# INSTALLATION CLEARANCE REQUIREMENTS ADDENDUM

The clearance requirements on page 9 and 11 of the Residential Hybrid Electric Heat Pump Water Heater Use and Care Guide have been restated as follows:

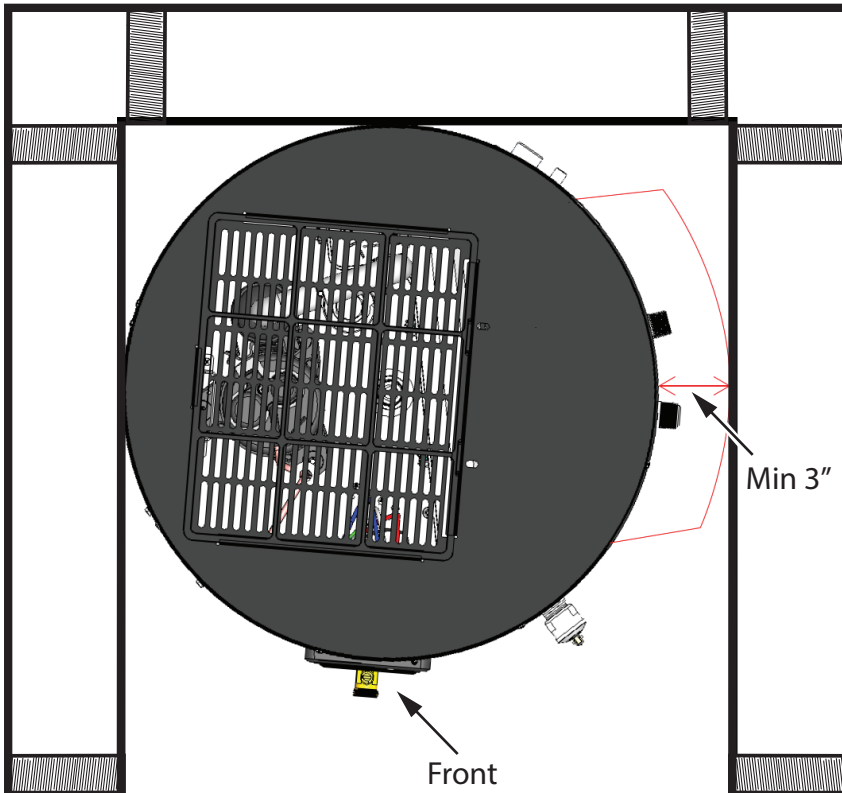
NOTICE: 50 gallon models may need to be slightly rotated clockwise to provide clearance for the condensate drain elbow. This is not necessary for the 66 or 80 gallon models.

Minimum Required Clearances			
Rear	Left Side	Right Side	Top
0"	0"	3"	6"
